Rep No. B19050
November 11, 2019
Fuji Electric FA Components
& Systems Co., Ltd.

Notification regarding Change to Internal Accessory Terminal Block Bracket Mounting Position
of BX Series Solid-State Molded Case Circuit Breaker

Current product	Changed product
<p>Front</p> 	<p>Front</p> 
<p>Side</p> 	<p>Side</p> 
<p>Side  magnified</p> 	<p>Side  magnified</p>

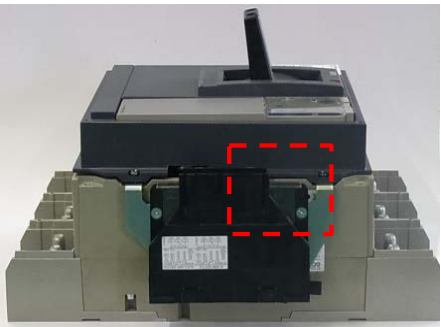
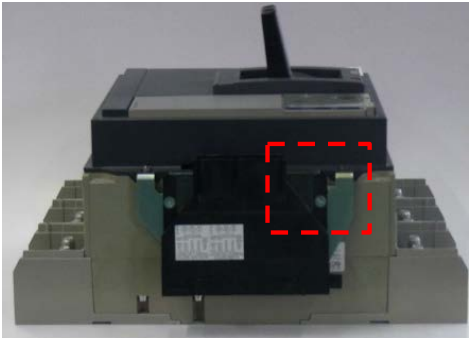
The position of the internal accessory terminal block mounting bracket will be changed from between the case and cover to the upper surface of the cover.
